MONTICELLO NUCLEAR GENERATING PLANT  
DOCKET 50-263  
LICENSE No. DPR-22

RESPONSE TO REQUEST FOR ADDITIONAL INFORMATION ON THE FOURTH 10-  
YEAR INSERVICE TESTING INTERVAL RELIEF REQUEST NO. PR 03  
(TAC NO. MB6807)

Attachment 1 - NMC RESPONSE TO NRC REQUEST FOR ADDITIONAL  
INFORMATION

#### ① Identified points on graph entitled, Inboard (relative to driver) Main Pump Bearing:

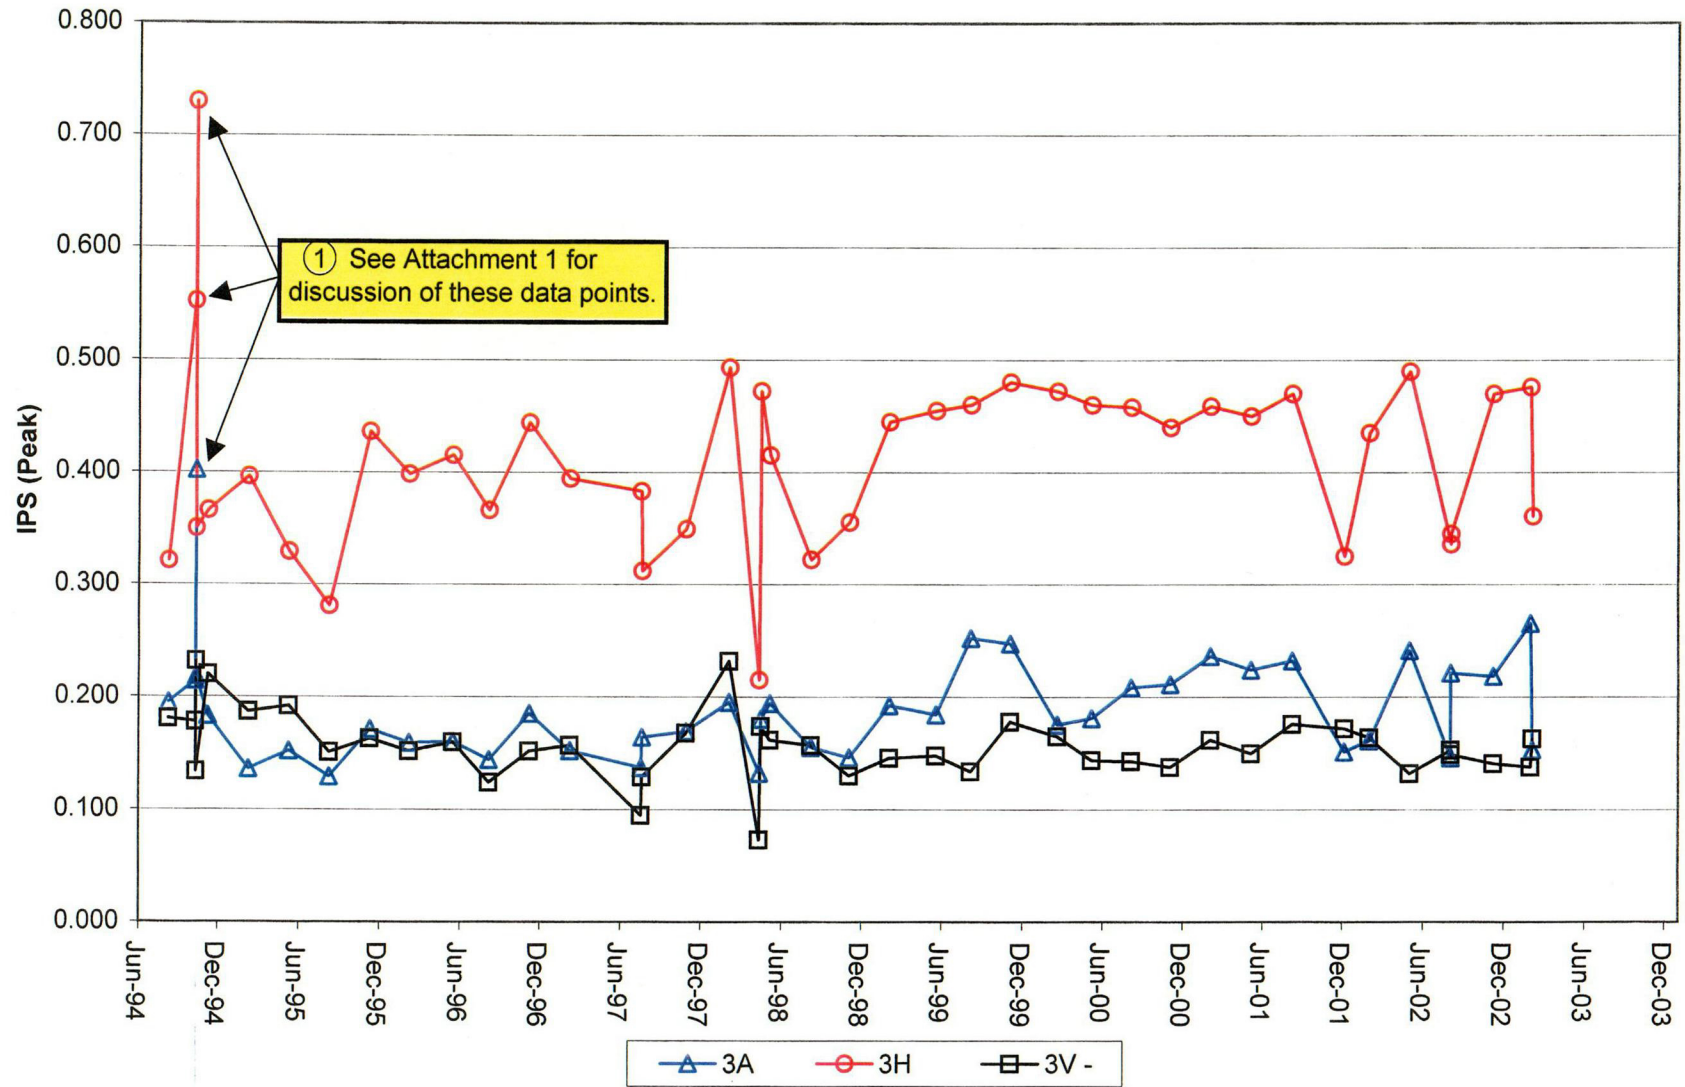
*It looks like we need more info. for Relief Request PR-03 for HPCI pump P-209. Do you have any additional vibration curves for the period between 1994 through present? Right now we appear to have only vibration curves from 1989 through 1994 (which were submitted with the 3rd interval IST Program).*

The identified points correspond to data, which is above the alert range for the HPC pump vibration limits. The points are discussed below:

- Data taken on 10/24/94 exceeded the 0.500 in/sec limit on point 3-H for IST.
- Data taken on 10/26/94 exceeded the 0.700 in/sec limit on point 3-H and the 0.325 in/sec limit on point 3-A for IST.

When the above readings were found the HPC pump was declared inoperable. In accordance with the referenced site practices, a condition report was initiated and an evaluation of the data was performed to determine the cause of the high vibration.

The results of the evaluation indicated that the above conditions were attributed to a turbine speed oscillation and other indication that was not reading accurately. This resulted in the turbine speed being set higher than the specified speed requirement for Section XI testing requirements. Although only point 3-H was specifically discussed in the engineering evaluation, the higher-than-normal vibration reading on point 3-A on 10/26/94 should have also been attributed to the same condition.

When the speed control problem was corrected and associated instruments were repaired and calibrated, the pump vibration test was re-performed on 10/27/94. The vibration data obtained was within the ASME Code and Relief Request limits, as applicable for the specific points.
